April 6, 2012

Cogentrix Quail Brush Generation Project – Docket Number 11-AFC-3, Data Request Responses to Set 2

Transmission System Engineering

ATTACHMENT L
PRE- AND POST-PROJECT PHYSICAL LAYOUT DRAWINGS

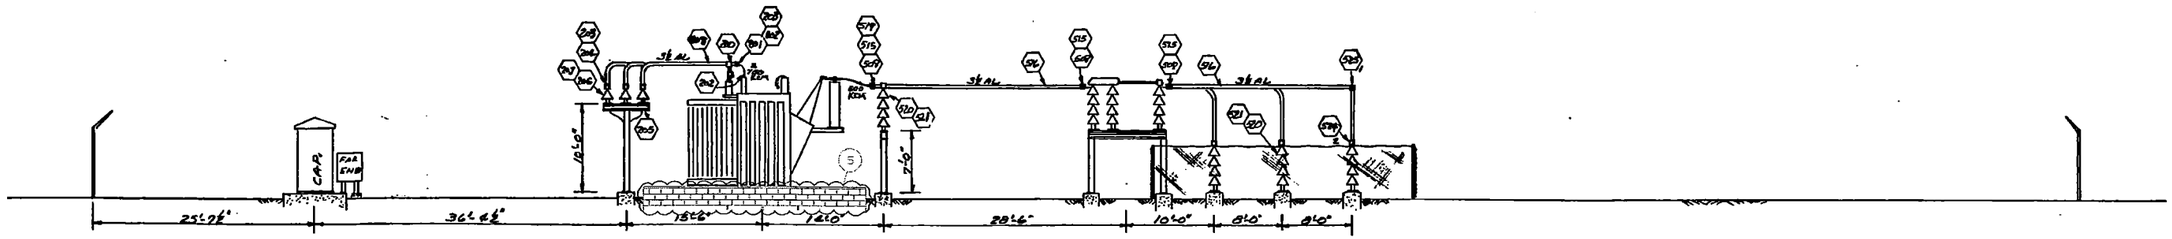
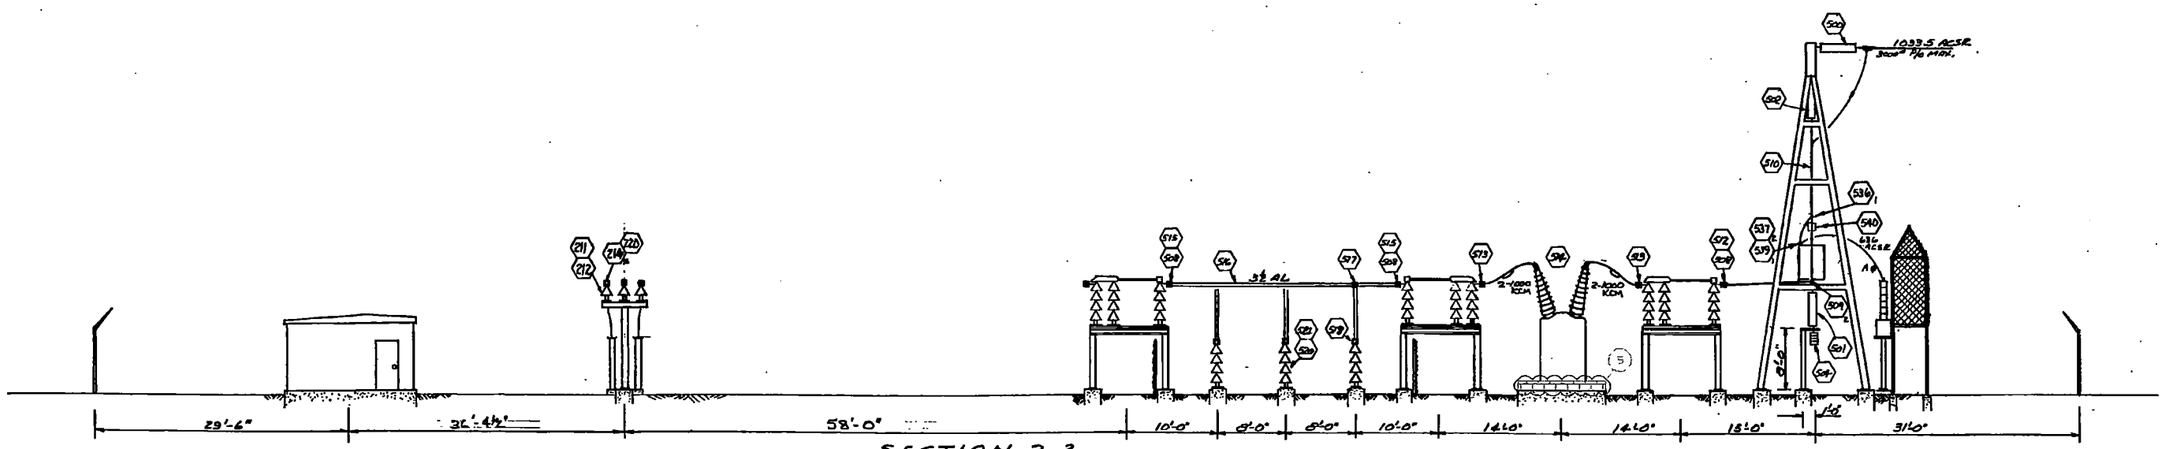
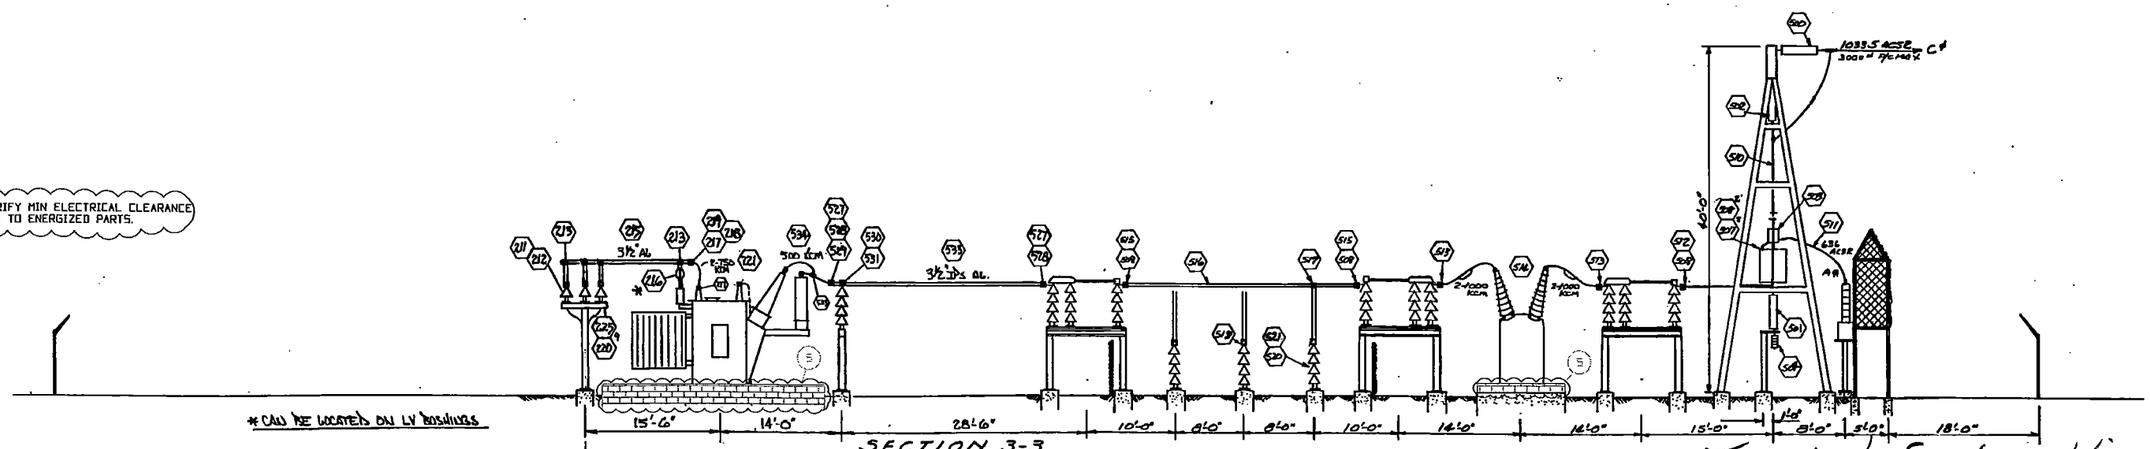
64. Also provide pre and post-project physical layout drawings of the SDG&E Carlton Hills 138 kV substation with all transmission outlets.

Pre-and post-Project physical layout drawings of the Carlton Hills 138 kV Substation have been provided by SDG&E and are attached as Attachment L. The post-Project physical layout (elevation drawing) at the Carlton Hills 138 kV Substation is represented by Section 2-2 on Attachment L. The pre- and post-Project general arrangements of the Carlton Hills 138 kV Substation are included in Attachment K.
